**Architectural Review Committee Meeting – Follow-up  
April 24, 2024**

**4:00 p.m. Compass Mixed Use project (157 West 9270 South), Nicholai Lazarev, Cole Peterson (Boyer Group), David Denison (Gardner Group), Ioanna Magiati, Jose Ho (AO Architects)**

North Elevation - 49%.

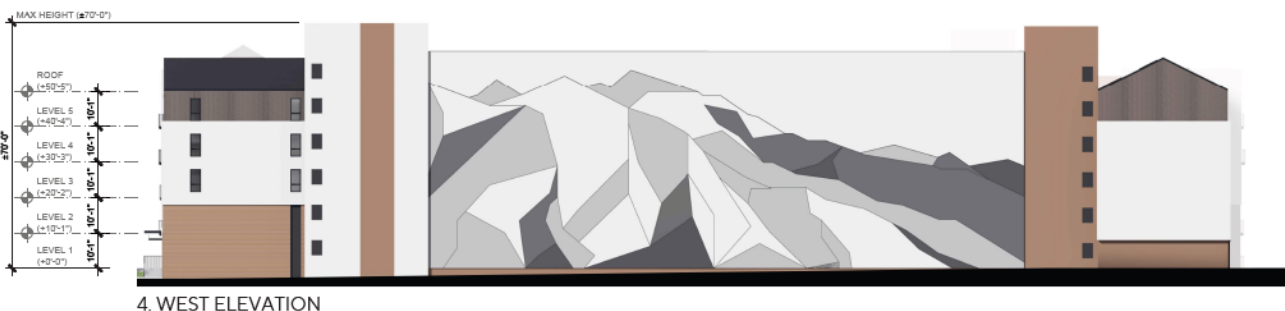
Cyndi wanted to know if it was the Cairns Design Standard that limits the percentage of stucco allowed on any project.

Mike stated that it was a citywide standard of 20% maximum per building face on all four sides of the building. He also wanted to know what the percentages were on each elevation.

Ioanna explained the percentages of stucco on each elevation, and the overall percentage of stucco on all the facades is close to 51-52%.

Brian asked if they had looked at ways of cutting down the stucco amount so that it was closer to the 20%.

Cyndi stated that she finds the elevations more appealing that have less percentage of white stucco (feels there is too much of it). However, she likes the building design/variations giving it a visual interest. She wants to make sure that the projects they approve will look good years to come.

David said they had discussed it thoroughly and were concerned if they did that, it would dramatically change the appearance of the building.

Scott Westra made a motion for positive recommendation to the Planning Commission, that they accept the stucco as it is designed, even though it exceeds the Design Standards. Cheryl Bottorf seconded. All in favor of the motion.

## Second Topic – Plaza

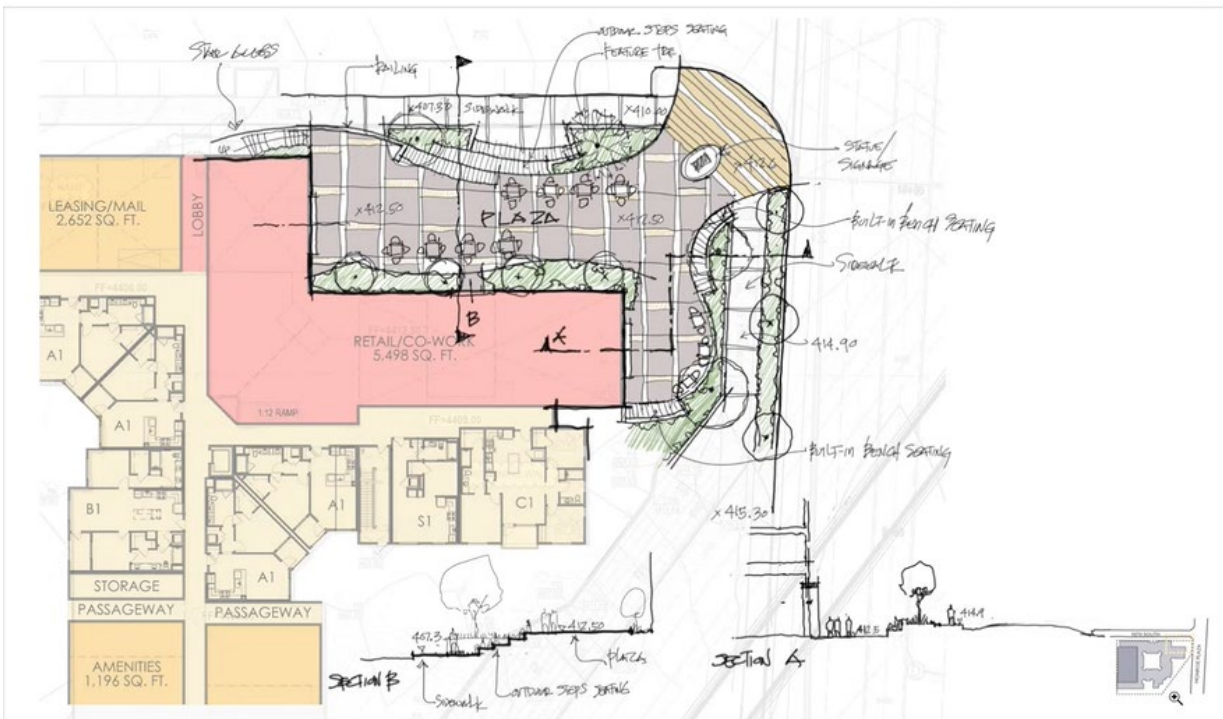
Steve wanted to know how they were achieving the grid pattern in the concrete.

Doug wanted to know if there was a ramp access that connects to the sidewalk on the northeast corner.

Steve wanted to know what they were planning to do with signage because it shows that on the plans.

Steve would like to see the awnings with glass roofs that would protect people from the elements.

Ioanna said they have not finalized the materials yet and would be happy to discuss and explore options.

Ioanna said they have redesigned to address ramping to street grade.

Ioanna said they would like to work with local artists to see what they could come up with for that area.

Nicholai said he would look into enclosing those awnings.

Steve Burt made a motion for a positive recommendation to the Planning Commission, that based off the conceptual design, the committee would like to make sure that the following items be included in the final design.

- Grid patterns are shown on the plaza itself

- They show different elements of concrete so that it is not just a big, flat, gray, concrete surface.
- The committee wants it noted that they do not have the authority to consider approval of any sign (that is located on the corner of plaza per the plans). Cheryl Bottorf seconded. All in favor of the motion.
